Application for Works Approval

Works Approval Number	W6833/2023/1
Applicant	Image Resources NL
ACN	063 977 579
File number	DER2023/000336
Premises	Nambung Station 2269 Wongonderrah Rd Nambung WA 6521 Legal description Lot 4113 on Deposited Plan 217467 Mining Tenement E 70/5034 As defined by the premises map in Schedule 1 of the issued works approval
Date of report	14 August 2024
Proposed Decision	Works approval granted

Grace Heydon
A/Manager, Waste Industries
Regulatory Services

Figure 1: Irrigation sprayfield groundwater contour map

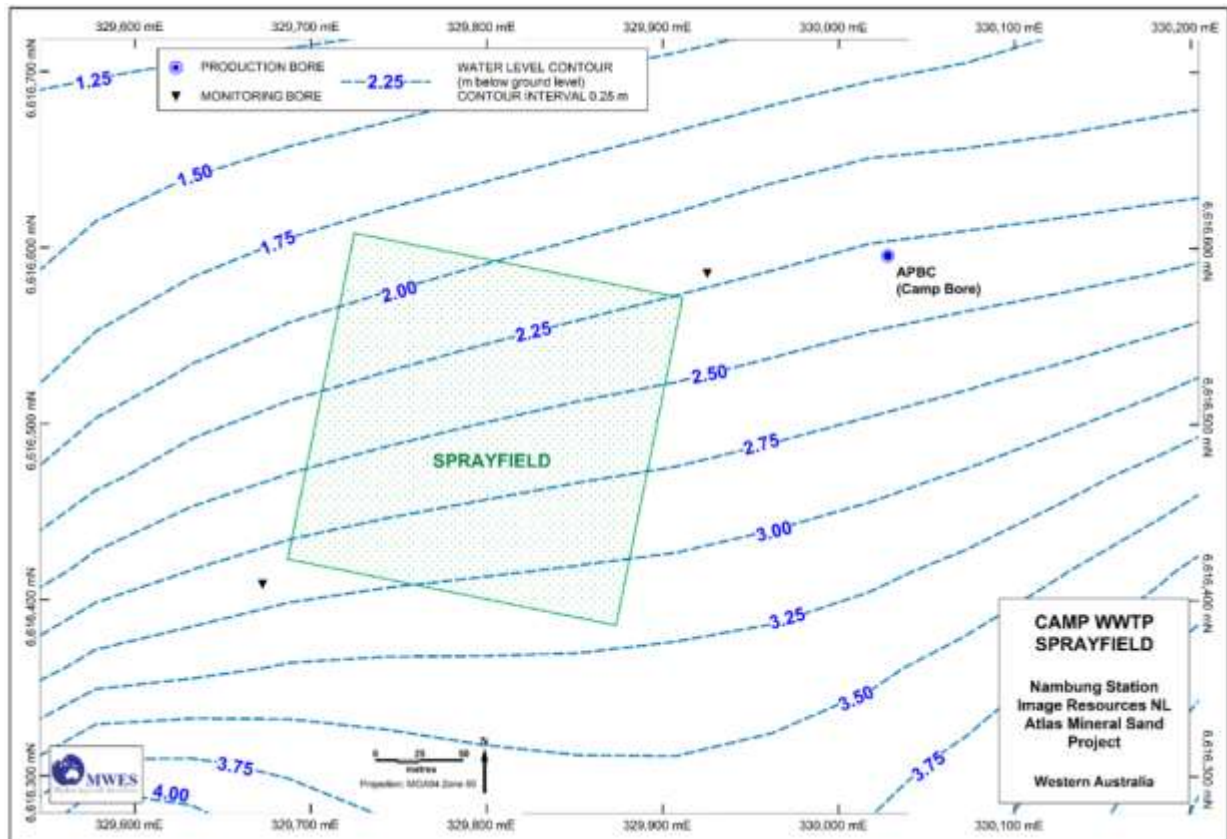
The department requested additional information on the depth to groundwater beneath the proposed irrigation sprayfield from the applicant as a part of this assessment. The applicant used data from seven bores surrounding the irrigation sprayfield to create a groundwater contour map. Data was collected in November 2022. The estimated depth to groundwater based on the contour map varies from approximately 1.8 mbgl in the northwestern corner of the sprayfield to approximately 3.2 mbgl in the southeastern corner of the sprayfield, as displayed in Figure 1 below.

As the data did not correlate with the on-site sampled data, the department's regional hydrologist was consulted for advice regarding the depth to groundwater in the vicinity of the irrigation sprayfield. A review of the groundwater contour map and raw bore data used to create the contour map was undertaken due to the discrepancies in data between the field samples taken by WML Consulting Engineers (2023a; 2023b) in November 2022 and the contour map provided by the applicant (Figure 1). An alternative and equally valid contour map was extrapolated from the same bore data showing possible groundwater levels closer to 1.75 m which correlated closely with data obtained during on-site sampling (Figure 2). Note that the depth to groundwater may be less during winter months.

Based on the information available, depth to groundwater within the vicinity of the sprayfield is likely to be within the range of 1.1 to 3.2 metres and may be less during peak winter levels.
